Comments on the Massachusetts Clean Energy Standard Discussion Draft Regulation

Signed Documents

[Attachment: 2014 Photo of the Pilgrim site]
Floodplain arrows are approximate

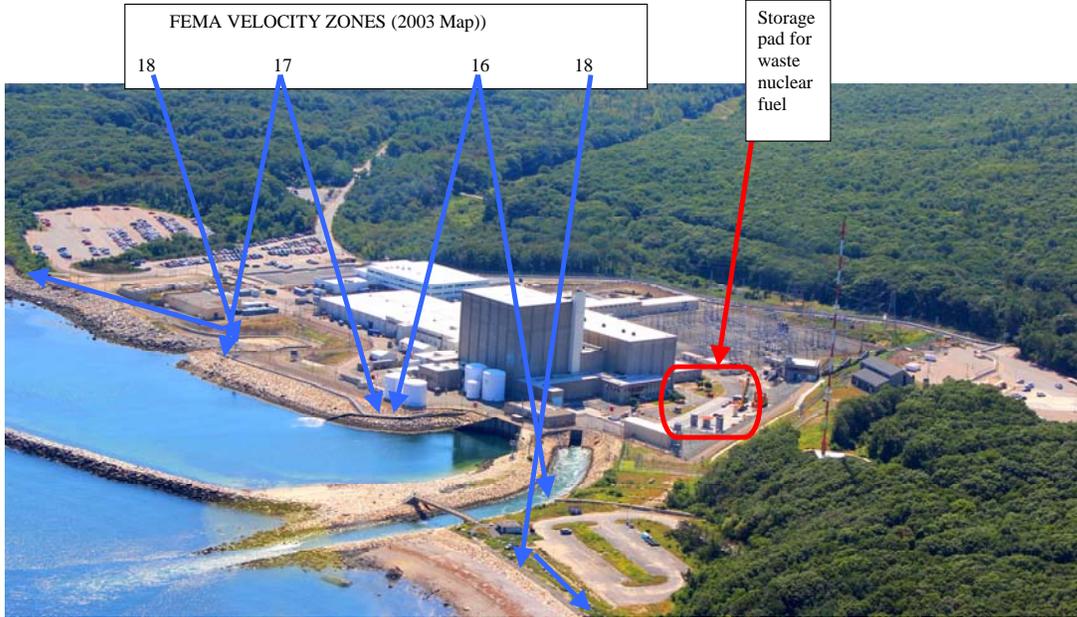
In the case of Pilgrim, the effects of climate change patterns (e.g., rising sea levels, warming sea water and air temperatures, increasing intensity of storms and related storm surges) are increasing risks to safety and environmental health. These patterns threaten the functionality of the facility's cooling system that is essential to normal (and safe) operations, are likely to cause flooding events that will have site-wide impacts, including destabilizing the dry cask nuclear waste storage facility being constructed only about 150 feet from the shore of the Bay (please see attachment: marked-up 2014 photo of the Pilgrim site).
